ITEM: 1155 Pine Street Landmark & Alteration Certificate Request

PROJECT INFORMATION:

REQUEST: A request to landmark the building at 1155 Pine Street, and request for an alteration certificate.

Annotated Mixed Use Overlay Land Use Map

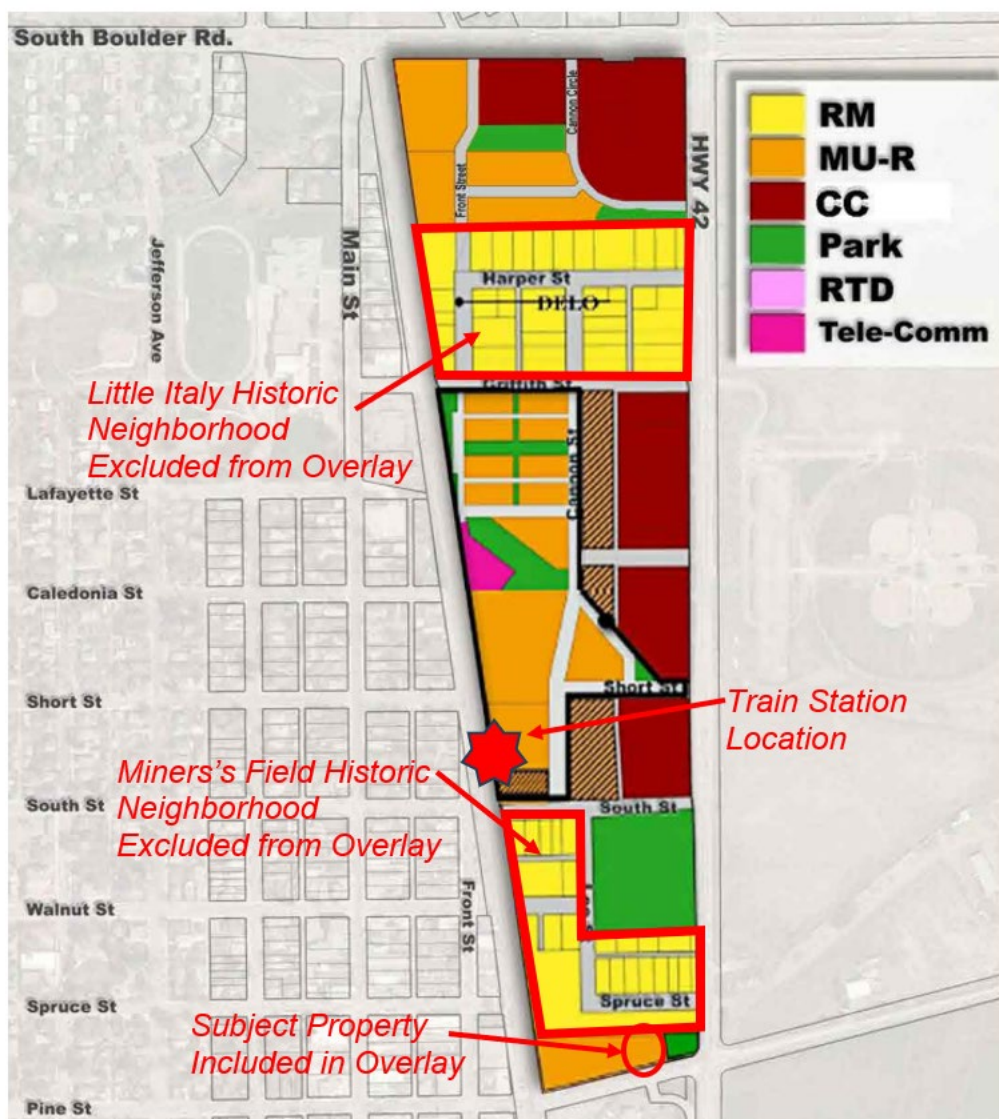
The overlay includes mandatory rezoning and redevelopment of certain properties within the district to implement the plan, including the subject property. Both the Little Italy and Minor's Field neighborhoods are excluded due to their historic value, but the plans explicitly designate the residential properties fronting Pine Street between the railroad tracks and Highway 42 for redevelopment under the MU-R district standards. By extension, this policy has prioritized redevelopment of the properties fronting Pine

Street ahead of potential historic significance. Landmarking any properties fronting Pine Street would eliminate the ability for redevelopment consistent with the established Mixed-Use code and policy.

1 SOUTH ELEVATION

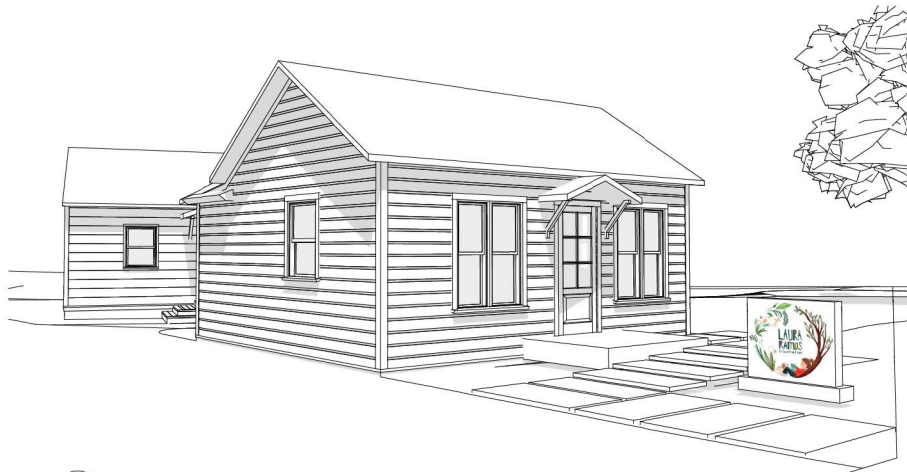
8. b. <i>The historic character of a property shall be retained and preserved. The removal of historic materials or alteration of features and spaces that characterize a property shall be avoided.</i>	No	The front windows are proposed to be altered to satisfy commercial design standards as part of the active Planned Unit Development application.

THIS SOUTH FACADE OPTION MODIFIES THE CURRENT WINDOW OPENINGS TO USE SIMILAR HISTORIC WINDOWS AS SEEN IN A 1948 PHOTOGRAPH OF THE HOUSE. THE HOUSE AT THAT TIME HAD A SINGLE WINDOW ON EITHER SIDE OF THE SOUTH FACING DOOR. THESE WINDOWS WERE TALL AND NARROW, LIKELY DOUBLE-HUNG WOOD WINDOWS, THAT WERE TYPICAL OF SIMILAR HOUSES THROUGHOUT LOUISVILLE AT THAT TIME. THIS OPTION USES THE HISTORIC WINDOW SIZES BUT ADDS TWO ADDITIONAL WINDOWS. THE CURRENT WINDOW OPENINGS ARE LARGER THAN THE HISTORIC WINDOW OPENINGS AND THIS OPTION USES THOSE LARGER OPENINGS. THIS OPTION ALSO BETTER COMPLIES WITH THE REQUIREMENTS OF THE NEW MU-R ZONING DISTRICT. ADDITIONALLY, A GABLE AWNING OVER THE SOUTH DOOR HAS BEEN RECREATED TO MATCH WHAT IS SEEN IN THE 1948 PHOTOGRAPH. IT IS BELIEVED THAT PART OF THIS AWNING STILL EXISTS AND WAS MOVED TO THE EAST FACING DOOR AT AN UNKNOWN TIME.
